# Access Compliance Report

## Public Rights-of-Way

Intersection ID: 7277	Main Street: NORTHRIDGE_VILLAGE_DR	Cross Street: TOM_HUNTER_RD	Location: NE
ADA ID: EEAC2A46A8DC	Ramp Type: ParaDiag	Initial Pass/Fail: Fail	Overall Compliance: No
Severity Score: 25			
Codes/Mitigation Info/Possible Solution		Field Measurements/Component Compliance

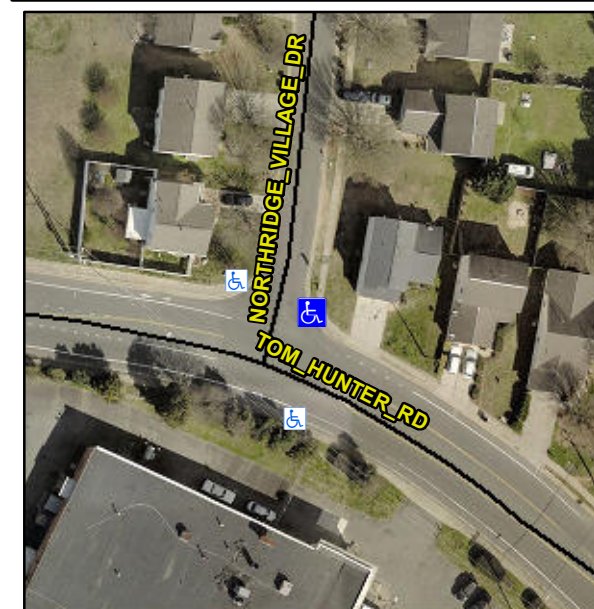
**VEGETATION OVERGROWTH, RT  
RP < 5%**

**R304.5.3**

**Remove & Replace Curb Ramp With Two New Directional Ramps or Equivalent.**
